Access Compliance Report

Public Rights-of-Way

Intersection ID: 10038262	Main Street: SMITH_RD	Cross Street: N/A	Location: SW
ADA ID: 0A9EEFDEFDC7	Ramp Type: PerpDiag	Initial Pass/Fail: Fail	Overall Compliance: No
		Severity Score: 22.5

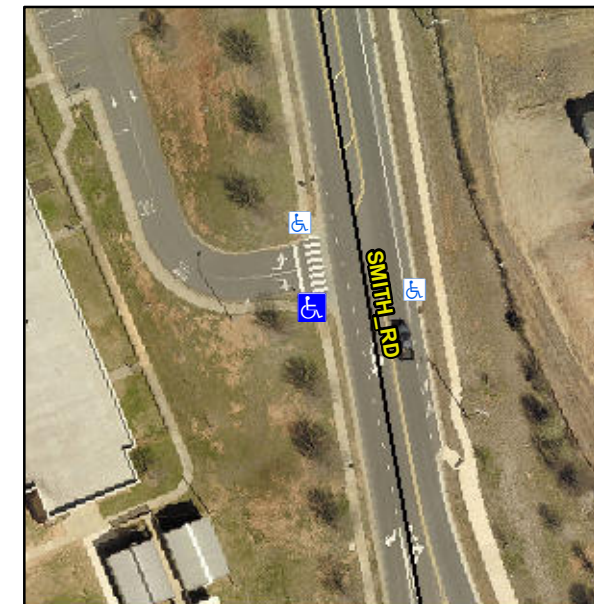
Not Found, R304.5.1, R304.2.2, R304.5.3

Compliance	Description	Data	Compliance	Description	Data
N/A	Ramp Length (in)	47.0	No	Ramp Slope (%)	9.2
No	Ramp Width (in)	47.0	No	Ramp XSlope (%)	2.7
N/A	Flare Type LT	N/A	N/A	Flare Type RT	N/A
N/A	Flare Slope LT (%)	N/A	N/A	Flare Slope RT (%)	N/A
N/A	Flare Traversable LT?	N/A	N/A	Flare Traversable RT?	N/A
N/A	Landing Length (in)	N/A	N/A	DWS Provided?	N/A
N/A	Landing Width (in)	N/A	N/A	DWS Contrast?	N/A
N/A	Landing Slope (%)	N/A	N/A	DWS Length (in)	N/A
N/A	Landing X Slope (%)	N/A	N/A	DWS Full Width?	N/A
N/A	Landing Curb? (Y/N)	N/A	N/A	DWS Offset (in)	N/A
N/A	Shared Landing?	N/A			
N/A	Gutter Ponding?	N/A	N/A	Gutter Slope (%)	N/A
N/A	Gutter Lip Ht (in)	N/A	N/A	Gutter X Slope (%)	N/A
N/A	Painted X Walk1?	No	N/A	Painted X Walk2?	Yes
	X Walk 1 Direction	To E		X Walk 2 Direction	To N
N/A	X Walk 1 Width (in)	N/A	N/A	X Walk 2 Width (in)	96.0
	X Walk 1 Slope (%)	2.0		X Walk 2 Slope (%)	3.0
	X Walk 1 X Slope (%)	2.2		X Walk 2 X Slope (%)	1.1

Remove & Replace Curb Ramp With Two New Directional Ramps or Equivalent.
